Project name: [REDACTED] Badgerys Creek Rd – Aerotropolis precinct plan review

Project number: 2055

Date: March 2021

This report outlines a preliminary review of the development potential of the site at [REDACTED] Badgerys Creek Road based on the Aerotropolis design principles and proposes some considered modifications to the current precinct plan.

Figure 5 Flood Model Comparison – Existing Conditions (ASEPP, Advisian and BMT)

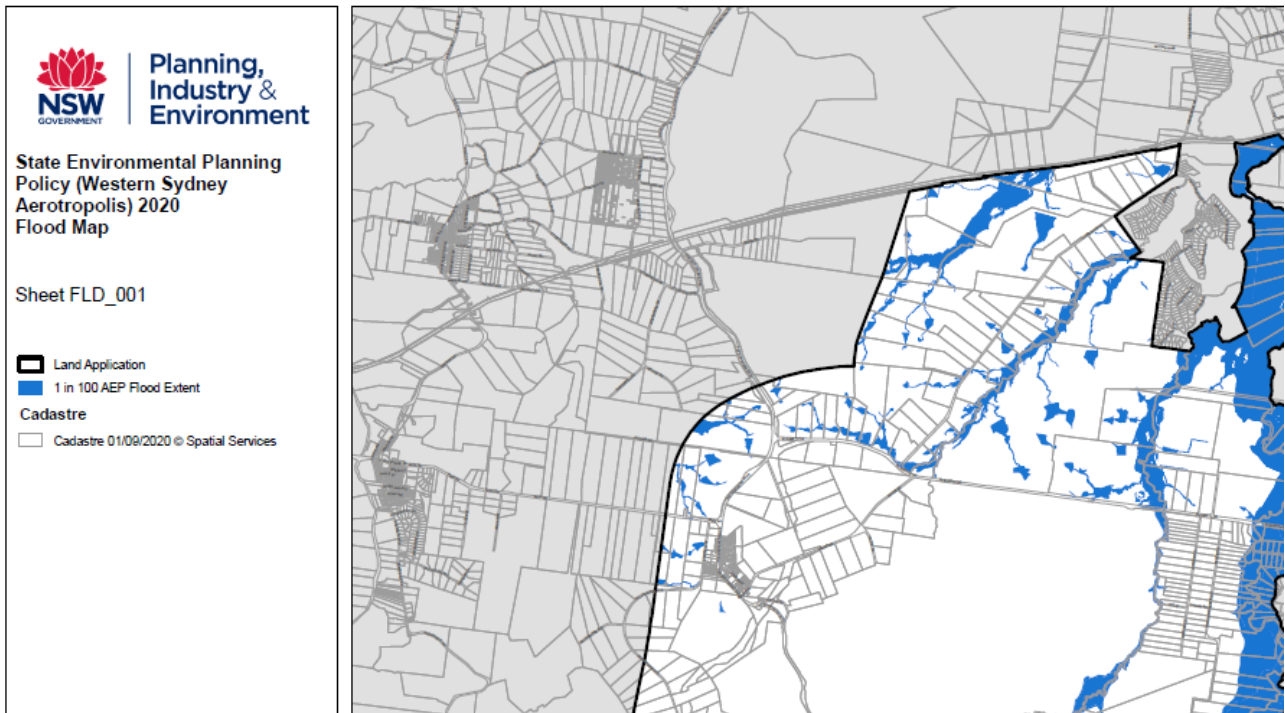
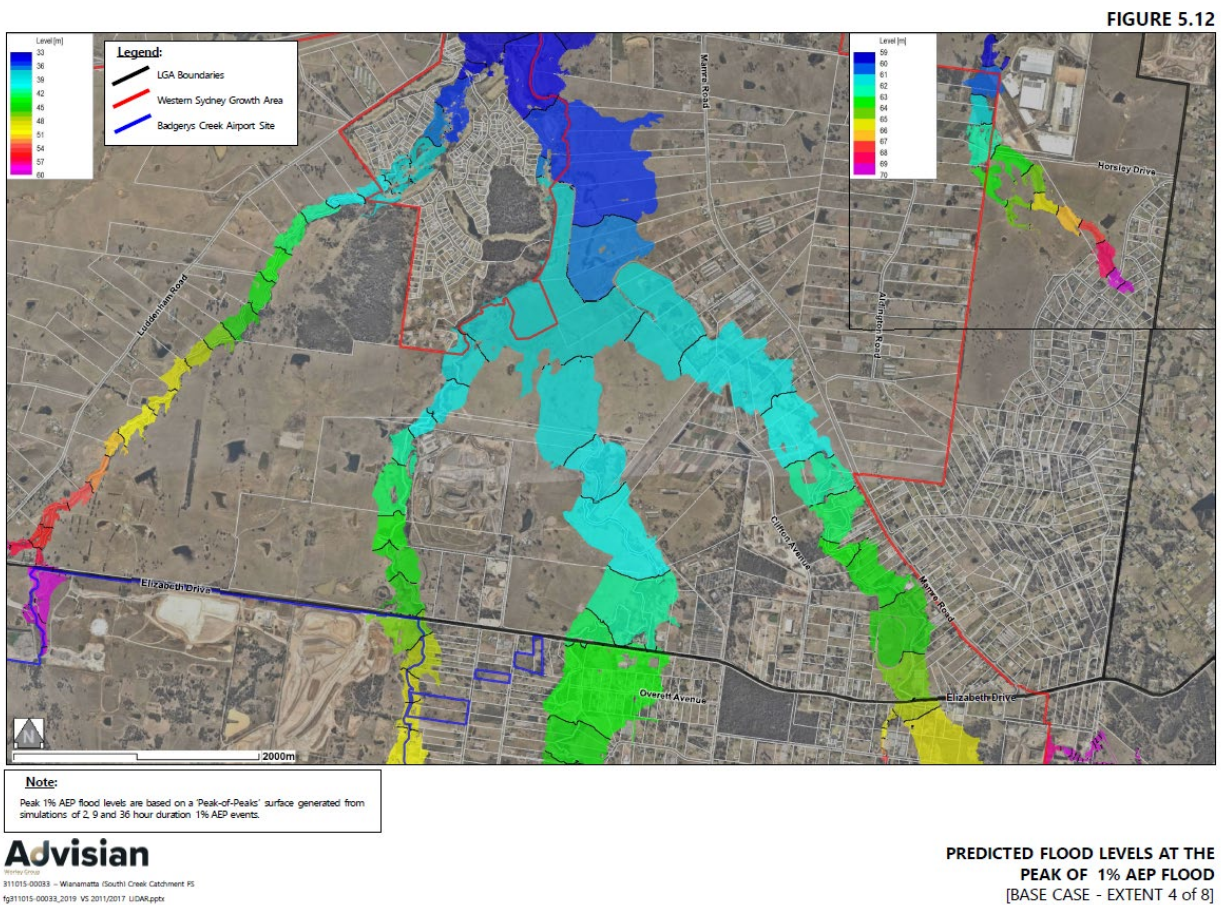
The SSDA seeks to provide an alternate solution to the treatment of water and open space that should be given every opportunity be assessed on merit which given the lack of any change to this ENZ, an entirely reasonable planning approach. As we have stated within the EIS for SSD 18406916, the field validation justifies the approach to seek development consent over the ENZ under s4.38(3) of the EP&A Act 1979 until such time that the ASEPP can be amended.

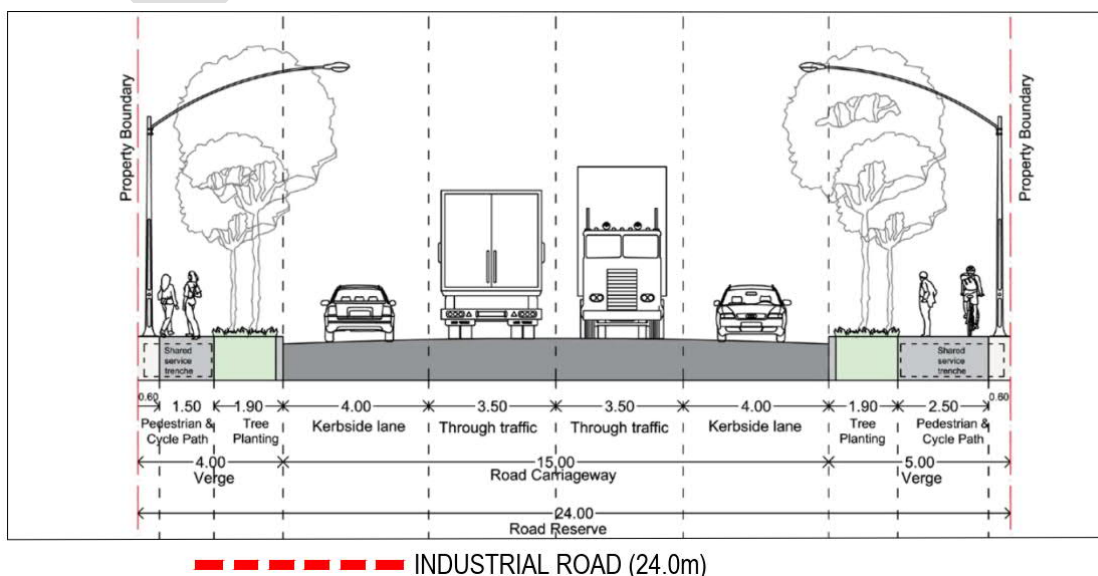
The guidelines whilst noting these constraints have not provisioned for the day-to-day requirements of these industrial precincts and typical users within them.

Likely suggested changes include.

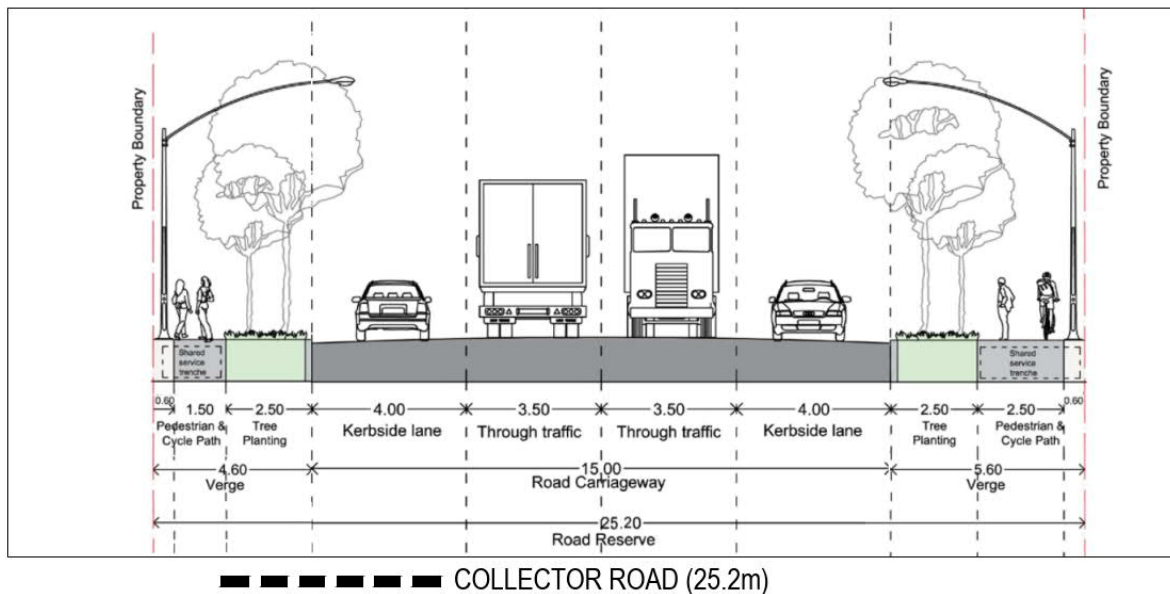
- One-way cross fall to the centre of the road could introduce a flooding and safety concern should the central stormwater system become blocked. We would suggest the crossfall be redirected to the outer kerb drainage system.

We would propose the Mamre Road 25.2m Cross Section be adopted.

Figure 7 – Stormwater Infrastructure – Open Space Needs Study

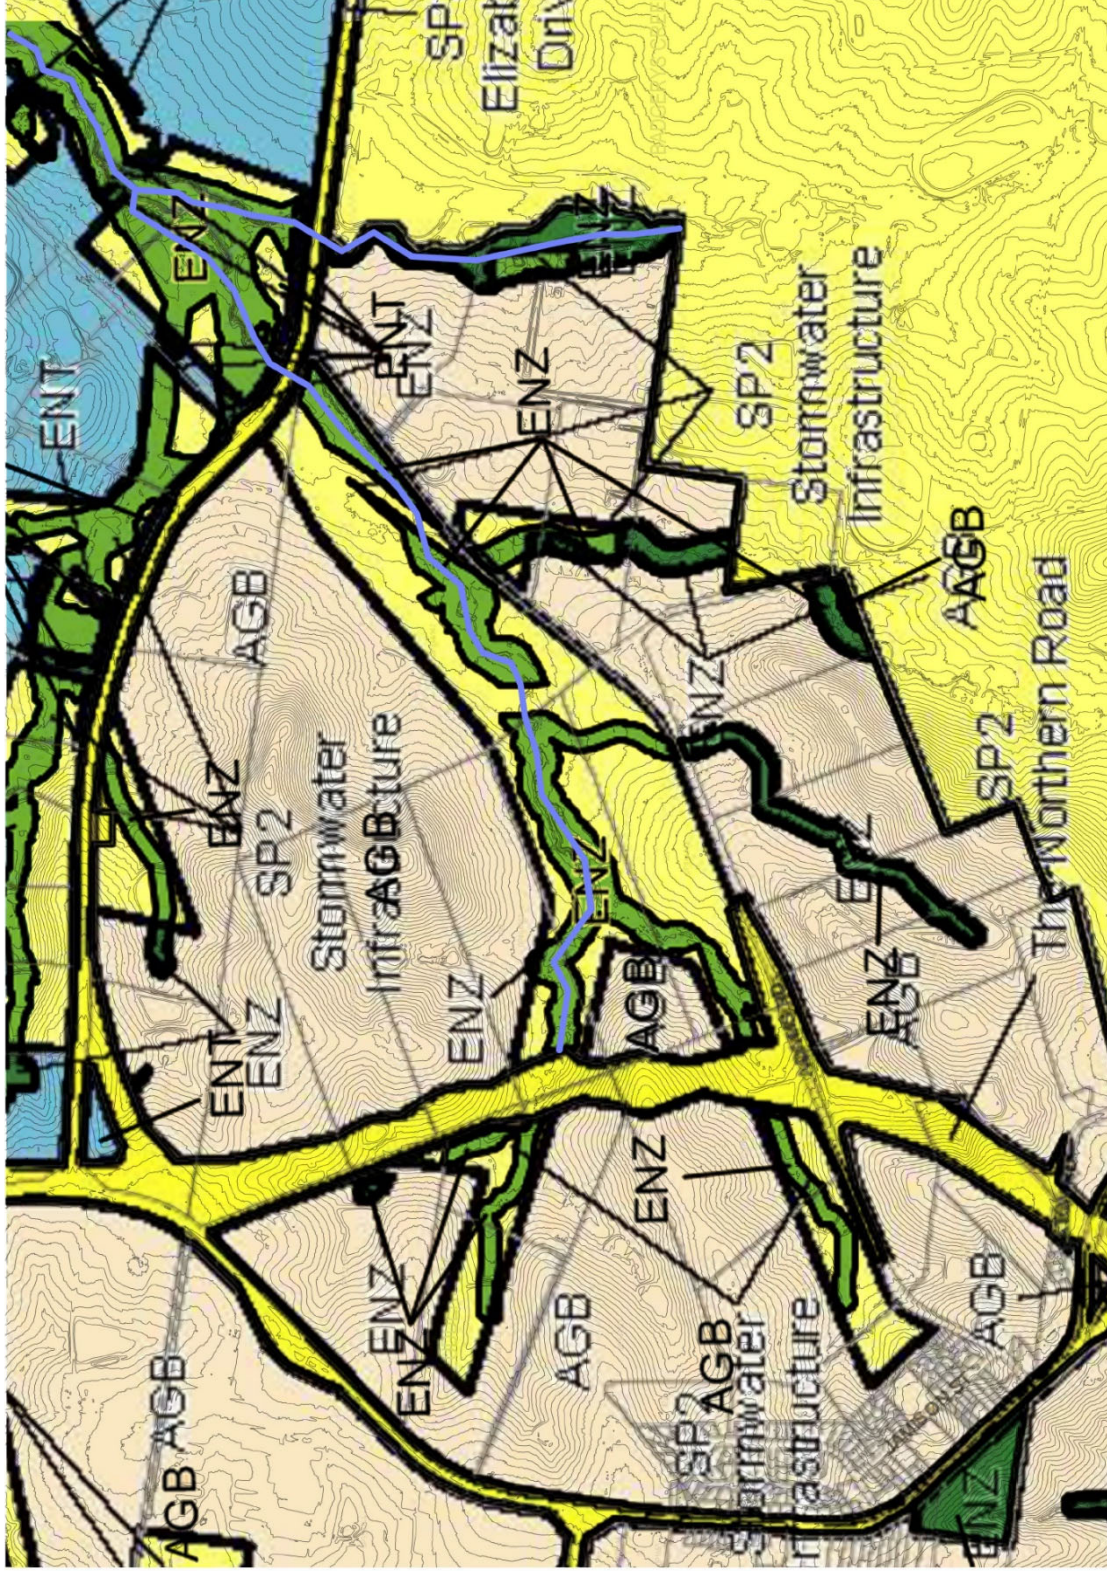
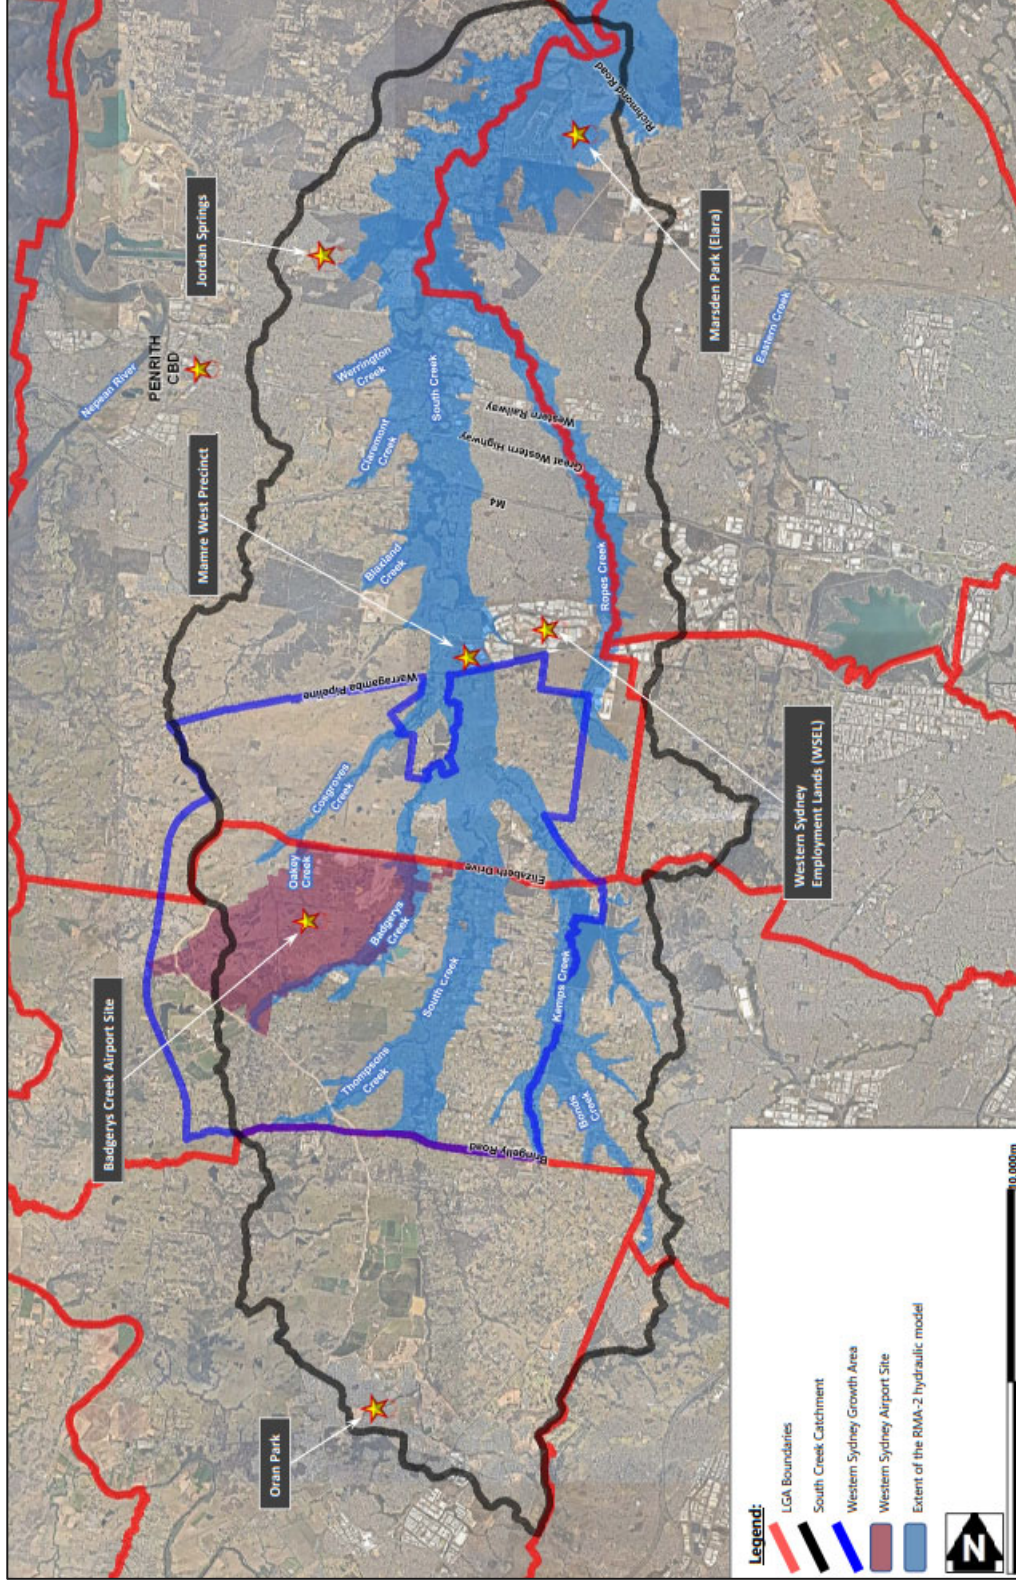
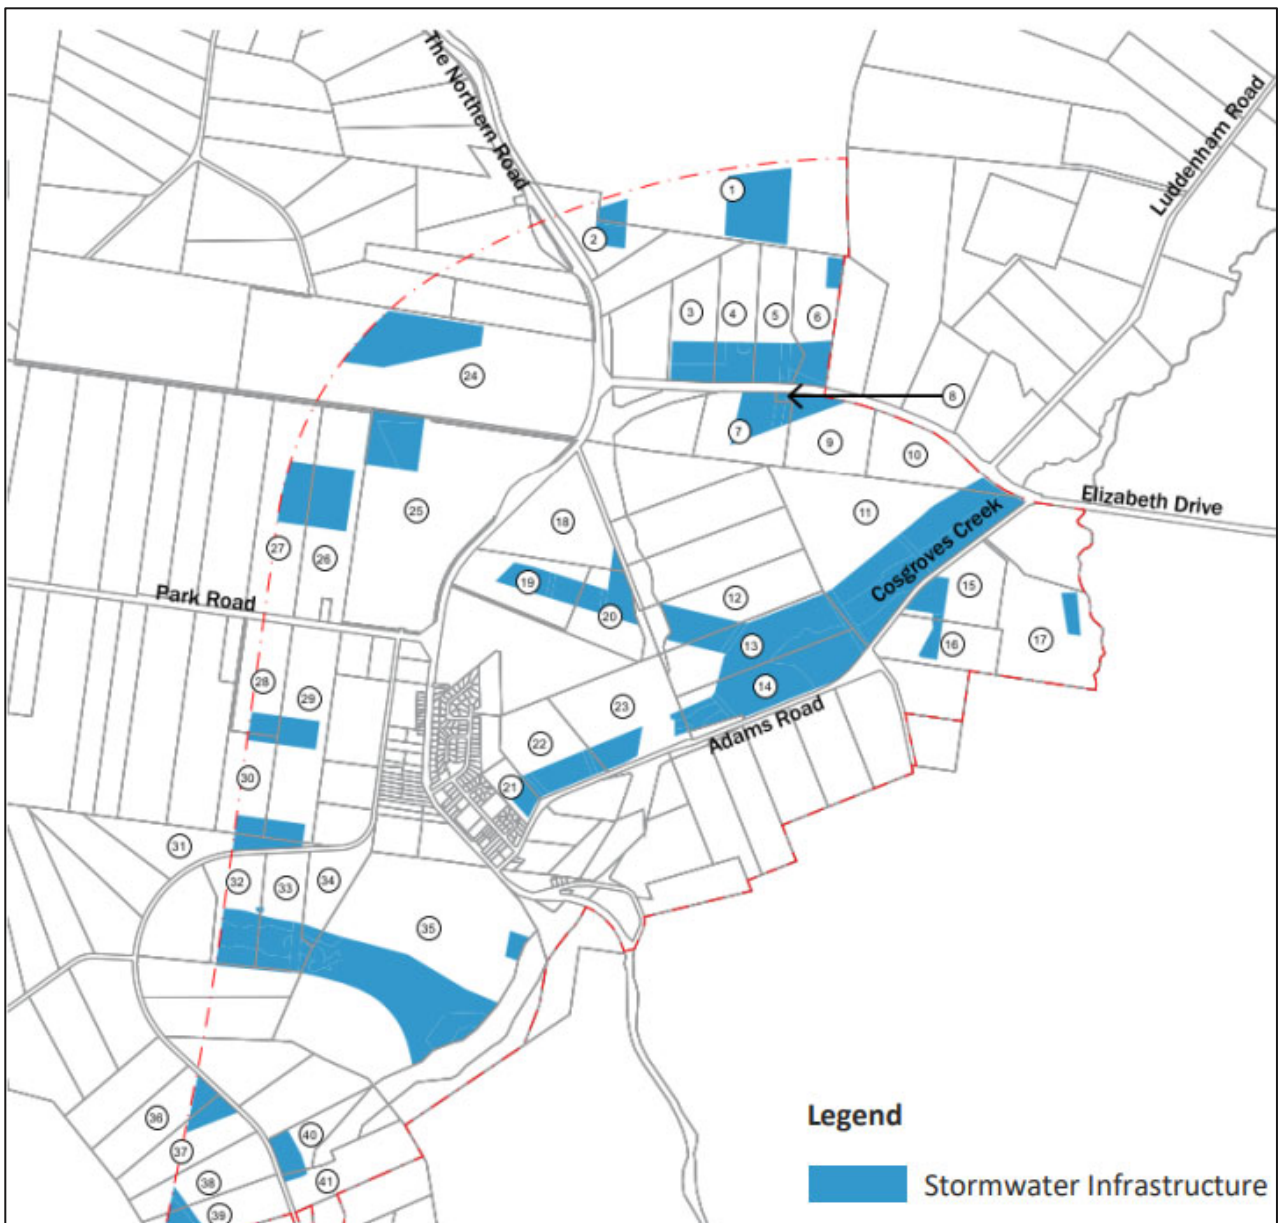
However, when considering the opens space designation as shown in **Figure 7** below against the Hydraulic model documents in Figure 6 and the location of the water course within the Consortium Lands as shown in Figure 5. It is clear that the open space designation extends well beyond, the creek line and the riparian corridor and extends well into the current Agribusiness zone that that is and is being used for agricultural purposes.

Despite the areas identified in blue in **Figure 7** being identified for acquisition via an SP2 Zone in the EIE, it is understood that a stormwater overlay is being considered by DPIE as an alternative. This overlay would identify the locations for this land that will be required for stormwater infrastructure and detention basins but not fix them within a specific SP2 Zone.
